UNITED STATES PATENT AND TRADEMARK OFFICE

APPLICATION NO.	FILING DATE	FIRST NAMED INVENTOR	ATTORNEY DOCKET NO.	CONFIRMATION NO.
10/524,942	02/08/2005	Giuseppe De'Longhi	23192	3137

Office Action Summary	Application No. 10/524,942	Applicant(s) DE'LONGHI, GIUSEPPE	
	Examiner Quang T. Van	Art Unit 3742

FIG. 3

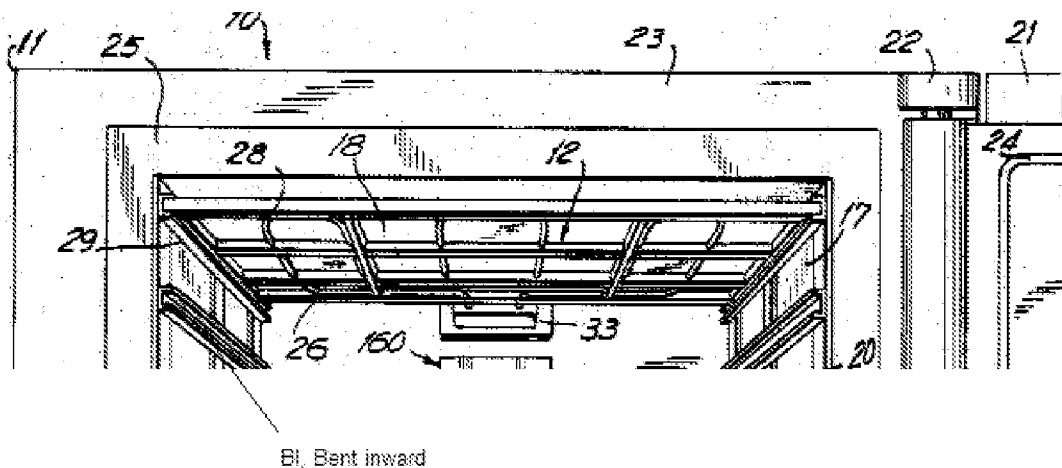
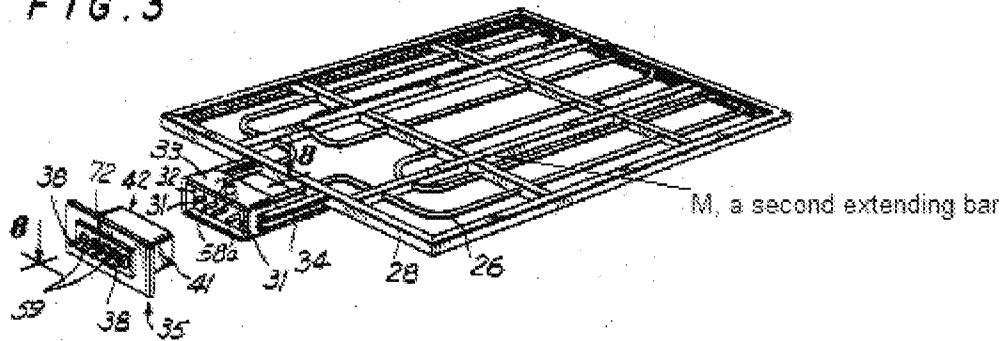
5. Claims 4, 17-18 are rejected under 35 U.S.C. 102(b) as being anticipated by Olof Fingal Christiansson (US 3,548,154) previously recited. Olof Fingal Christiansson discloses an electric heating oven comprising a housing (10); a plurality of resistors (26, Figure 1) in the housing electrically energizable to radiate heat, at least one of the resistors (26) having a longitudinally extending portion and subdividing the housing into an upper baking chamber and a lower baking chamber; and a support frame in the housing and including a pair of longitudinally extending first bars (28) flanking and slidably receiving the portion of the one resistor (26) and forming a longitudinally extending seat therefore, a second longitudinally extending bar (M, Figure below) being oriented so as to deflect radiant energy from the portion into the lower chamber, second transversely extending bars (29) bent upward and connected to said first bars (Figure below), and portions bent inward (BI) and holding the portion of the one resistor in the seat.

9. Applicant argues that "Christiansson lacks specifically recited structure of amended claim 17, namely two "baking" chambers and a "longitudinal" bar extending above a "longitudinal" portion of the heater. The examiner disagrees. Christiansson discloses two baking chambers defined by the space above and below a resistor (26), and the two baking chambers spaces are depended on the location of the resistor (26) is connected to different level contacts (57) which are attached to the back wall (Figure 1). Therefore, Christiansson is clearly defined the two chambers. Christiansson also discloses a "longitudinal" bar (M, Figure above) extending above a "longitudinal" portion of the heater (26).
